IEEE P802.15 Wireless Personal Area Networks

Project	IEEE P802.15 Working Group for Wireless Personal Area Networks (WPANs)	
Title	TG3 SB1 comment resolution	
Date Submitted	[4 February, 2003]	
Source	[James P. K. Gilb] [Apparent Technologies] [15373 Innovation Drive, #210, San Diego, CA 92129]	Voice: [858-485-6401] Fax: [858-485-6406] E-mail: [gilb@ieee.org]
Re:	[]	
Abstract	[This document is a record of comment resolutions for SB1.]	
Purpose	[To provide a record of the comment resolution for SB1.]	
Notice	This document has been prepared to assist the IEEE P802.15. It is offered as a basis for discussion and is not binding on the contributing individual(s) or organization(s). The material in this document is subject to change in form and content after further study. The contributor(s) reserve(s) the right to add, amend or withdraw material contained herein.	
Release	The contributor acknowledges and accepts that this contribution becomes the property of IEEE and may be made publicly available by P802.15.

Figure 2—MSC for the handing over control of a private, pseudo-static CTA

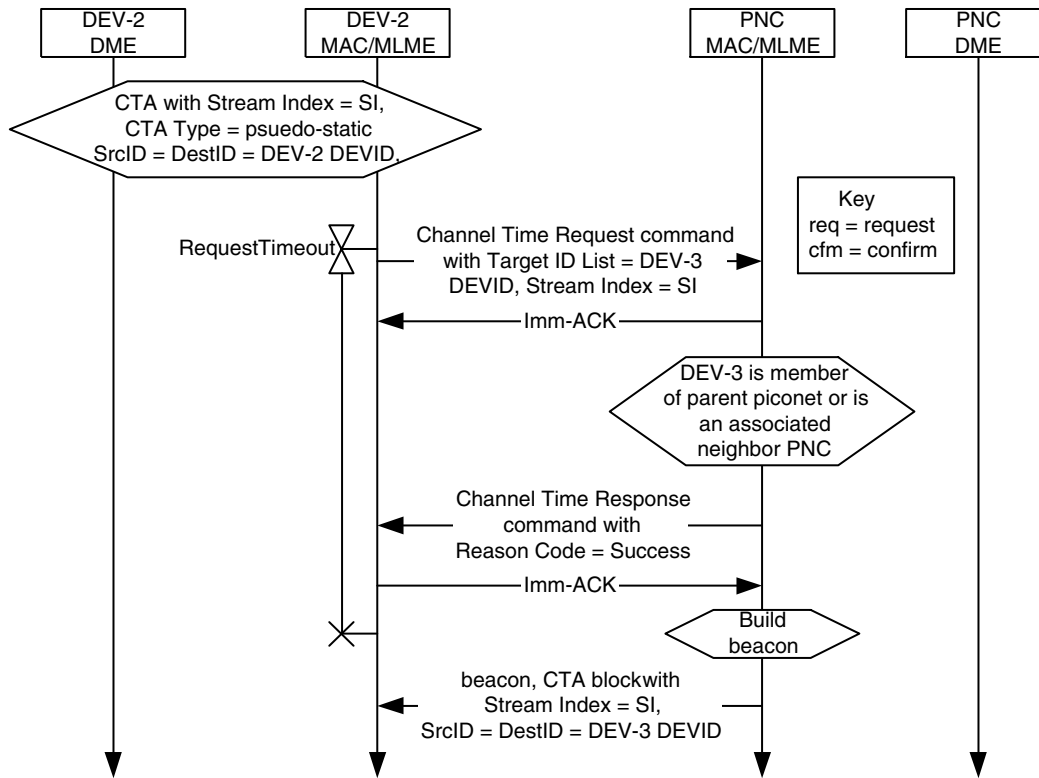
Add new text to 8.5.1.2,

If the target DEV indicated in the Target ID List is either a member of the parent piconet or is a associated neighbor PNC and the Channel Time Request command has the correct entries as indicated above, the parent PNC shall grant the request to change the source and destination for the stream and shall send a Channel Time Response command to the originator with the Reason Code set to 'Success'. The PNC shall continue to place the CTA block for the allocation in the beacon but shall change the SrcID and DestID to be equal to the target's DEVID. Once the PNC has changed the SrcID and DestID in the CTA block, the target DEV will have gained control of the CTA and will be allowed to request modifications or the termination of the allocation.

If the target DEV is not a member of the piconet and it is not an associated neighbor PNC, the parent PNC shall reject the request and shall send a Channel Time Response command to the originator with the Reason Code set to either 'DEV unassociated' or 'DEV unauthenticated' depending on the status of the Target DEV.

The MSC for the handover of the control of a private, pseudo-static CTA is illustrated in Figure 2.

Figure 3—Successful PNC handover in a dependent piconet.

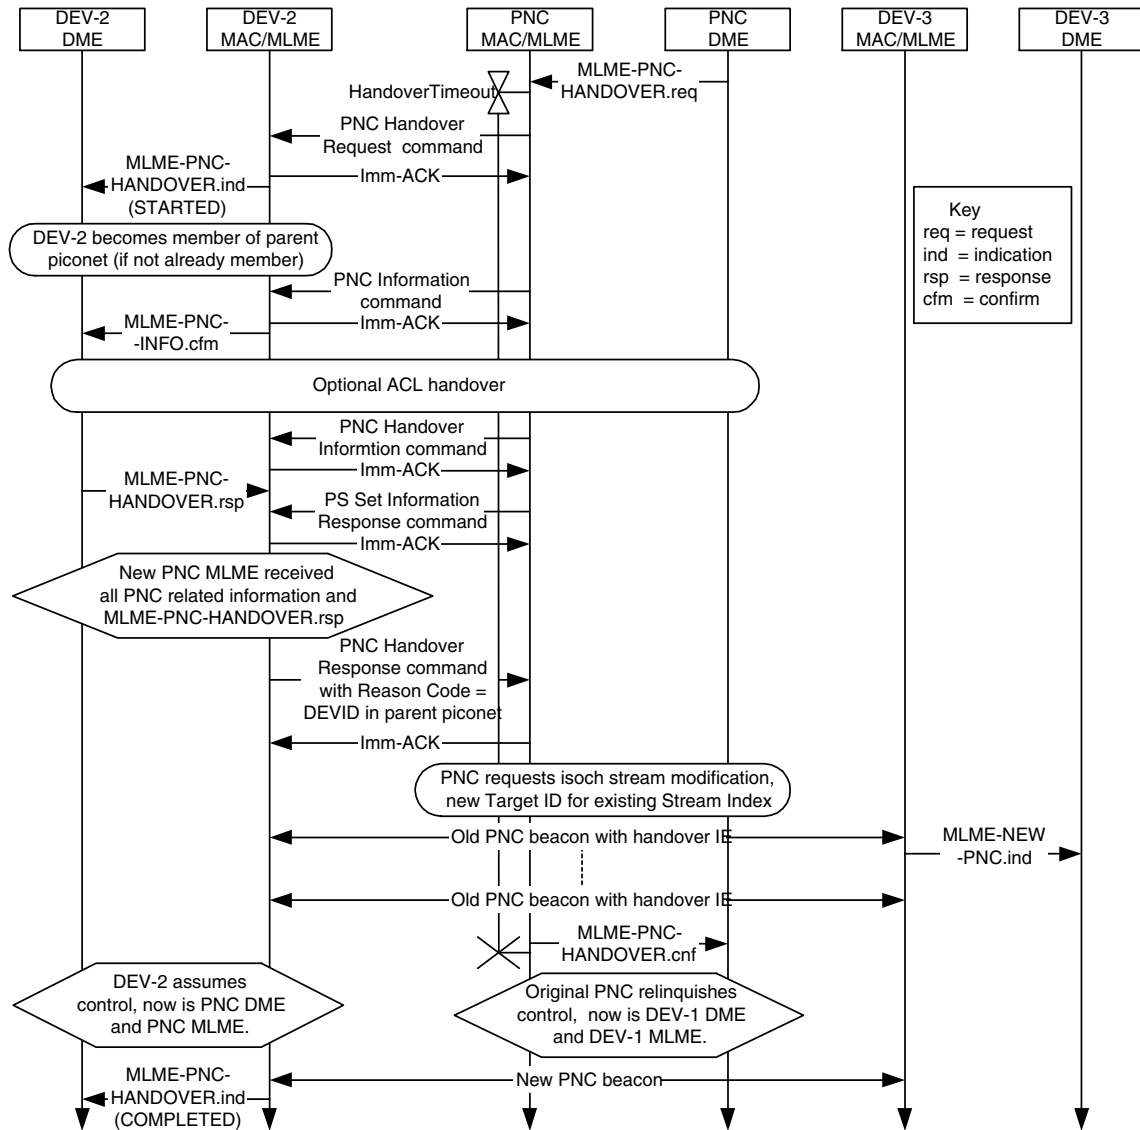
The dependent PNC handover process begins in the same manner as a regular PNC handover, {xref 8.2.3}, with the current PNC sending the PNC Handover Request Command to the target DEV that it has selected to become the new PNC, as shown in Figure 3. In this and the two subsequent figures, the identities PNC, DEV-2 and DEV-3 are all relative to the dependent piconet and not the parent piconet. If the target DEV is not a member of the parent piconet, then that DEV shall begin the association process to join the parent piconet.

net and, if required, authenticate with the parent PNC. The target DEV may request to associate with the parent piconet as either a neighbor PNC or as a member of the piconet. While target DEV is attempting to join the parent piconet, the current dependent PNC shall send the target DEV the information about all of the DEVs with the PNC Information command, all of the current channel time requests with the PNC Handover Information command and the power save information, if any, using the PS Set Information Response command. The target DEV may also request the transfer of any ACL data at this point using the ACL Information Request command. Note that the transfer of this information will not interfere with the target DEV's association and authentication process because the former occurs only during time reserved for the dependent piconet while the latter only occurs during time reserved for the parent piconet.

Once the transfer of the information is complete and target DEV has joined the parent piconet, the target DEV shall send a PNC Handover Response command to the dependent PNC with a Result Code set to the

DEVID that was assigned to it by the parent PNC. This lets the dependent PNC know that the target DEV is ready take over control of the piconet. At this point, the dependent PNC shall send a Channel Time Request command to the parent PNC to handover the control of the dependent piconet CTA to the new dependent PNC, {xref 8.5.1.2 stream modification}. Once the parent PNC changes the SrcID and DestID of the dependent piconet CTA, the current dependent PNC shall either complete the handover process to the new PNC or it shall shutdown the dependent piconet because it will not be able to regain control of the CTA.

Figure 4—Failed dependent PNC handover when target DEV fails to join parent piconet.

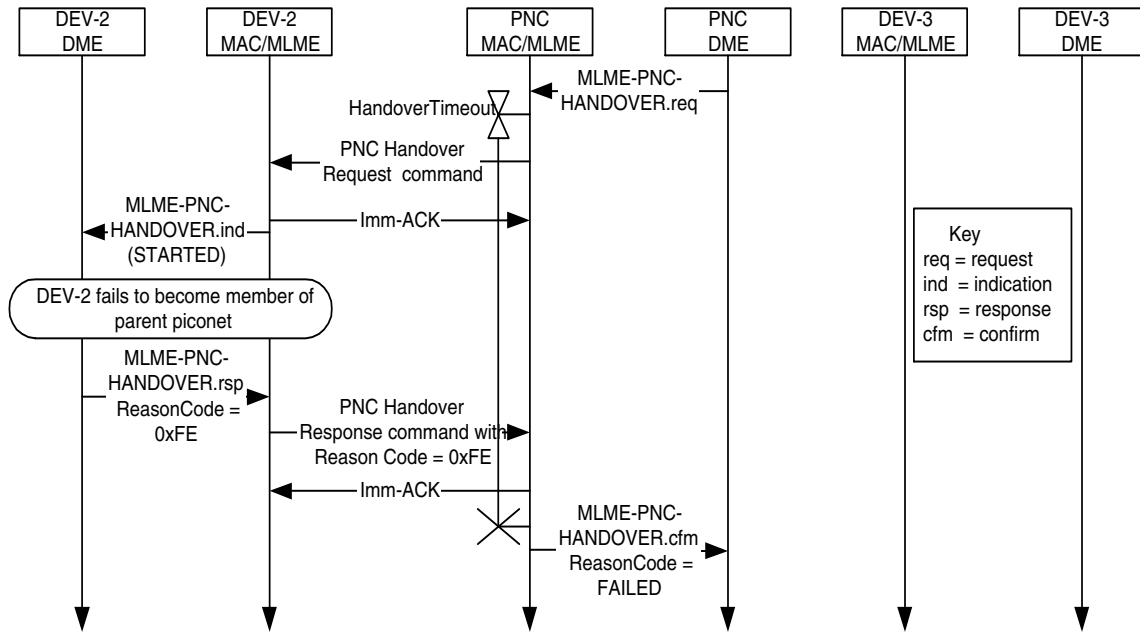
If the target DEV fails to join the parent piconet as either a regular DEV or as a neighbor PNC, it shall send the PNC Handover Response command to the dependent PNC with the Reason Code set to 'Handover

refused, unable to join parent piconet' as illustrated in Figure 4. The target DEV may refuse the handover at any time while the dependent PNC is sending over the information about the piconet.

Figure 5—Failed dependent PNC handover when control for the dependent piconet CTA is handed over in the parent piconet.

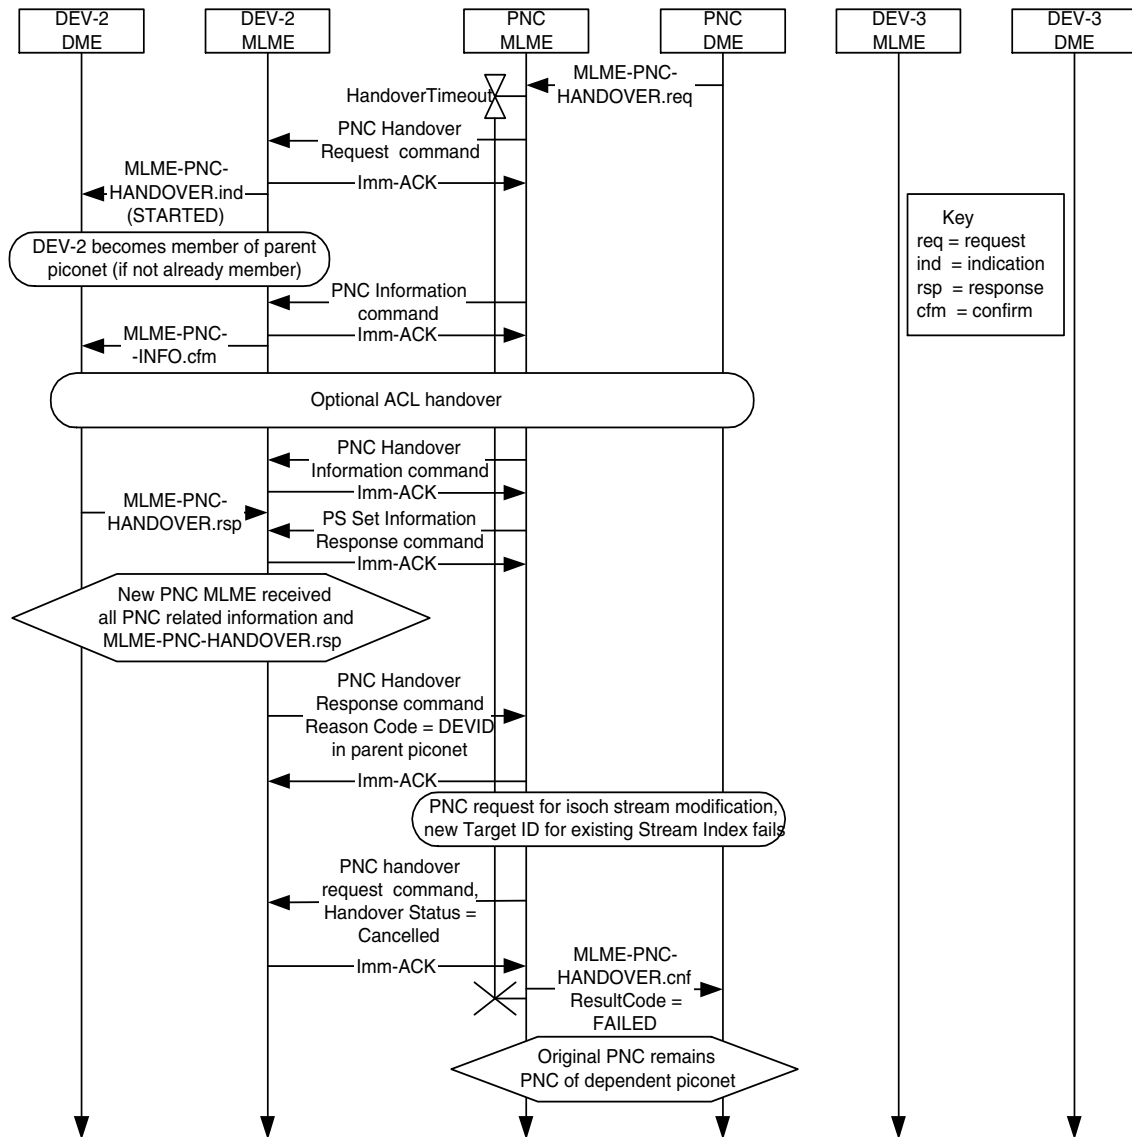
If the parent PNC rejects the request to handover control of the CTA to the new dependent PNC, the dependent PNC shall send a PNC Handover Request command to the target DEV with the Handover Status field set to 1 to indicate that the handover process is being cancelled, as illustrated in Figure 5.

If the dependent PNC cancels the handover process, the target DEV may disassociate from the parent piconet. If DEV-2 joined the parent piconet as a neighbor PNC, it should disassociate from the parent piconet if the handover process is cancelled to free up that resource for other DEVs that may want to form a neighbor piconet.

Figure 6—Channel time request for frames with immediate ACKs

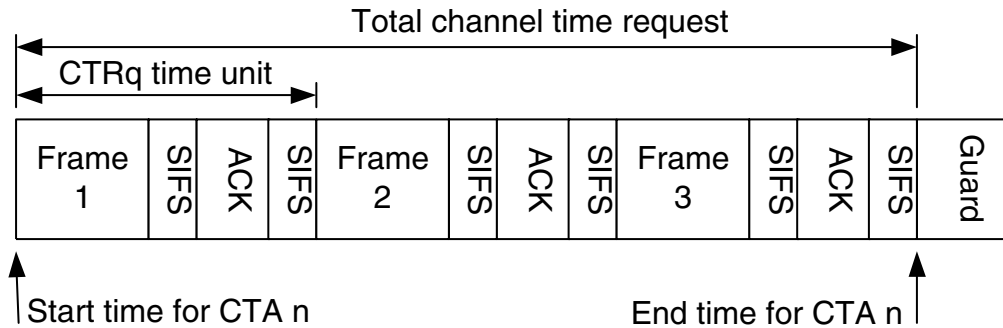
CID 682: - **Suggest accept in principle:** The inclusion of MIFS changed the CTR calculations, but the changes were not reflected in 8.4.4.6. '1)Change b3 in Figure 79 from "stream termination" to "MIFS CTRq TU". 2)Replace page 152, line 12 with:

The requesting DEV shall include the frame transmission time, if known *a priori*, and the ACK transmission time, if used, and MIFS or SIFS time as appropriate per frame or ACK when calculating channel time

requests. Figure 6 (was #108) shows an example of channel time being requested for a CTA where Imm-ACKs are used.

Figure 7—Channel time request with no ACKs

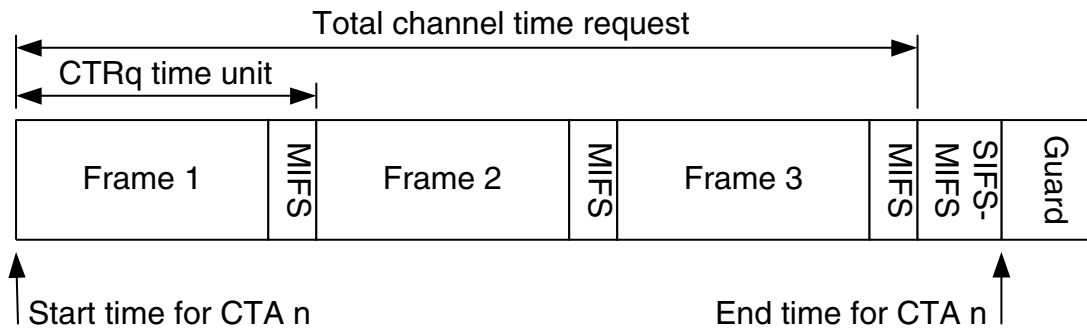
When No-ACK is used, the channel time request is calculated differently because there is a MIFS in between each frame in the CTA instead of a SIFS. A channel time request that uses a CTRq TU with MIFS instead of SIFS shall set the CTRq TU MIFS bit to one to inform the PNC that it must add a time equal to SIFS-MIFS to the end of the CTA. This ensures that there is a SIFS between the end of transmission in one CTA and the start of the next. Figure 7 shows an example of a channel time request when no-ACK is used and the MIFS bit is set in the Channel Time Request command.

Figure 8—CTRq time unit covering multiple frames with no-ACK policy

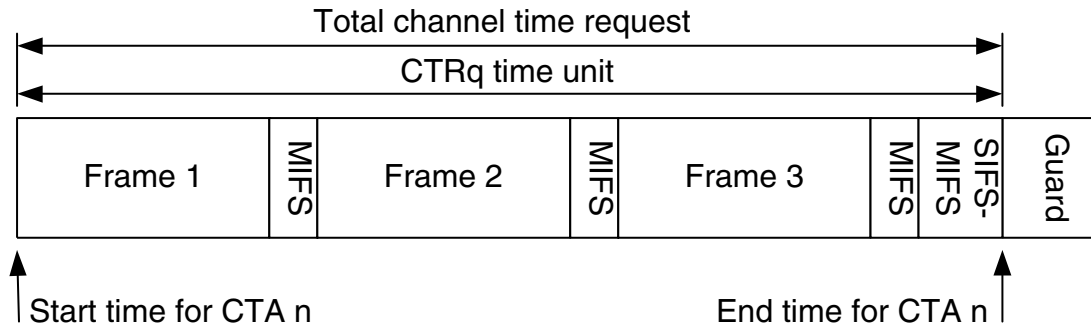
A CTRq TU in the CTA may cover more than one frame as shown in Figure 8. If the requesting DEV included SIFS-MIFS following the last MIFS as shown in Figure 8 it shall set the CTRq TU MIFS in the

Channel Time Request to "0." IF SIFS-MIFS is not included in the CTRq TU, the CTRq TU MIFS bit shall be set to "1" and the PNC shall add SIFS-MIFS to the CTRq TU to calculate the duration of the CTA.

Accept in principle with the text above and an additional figure for the time when the CTRq TU does not include the SIFS.
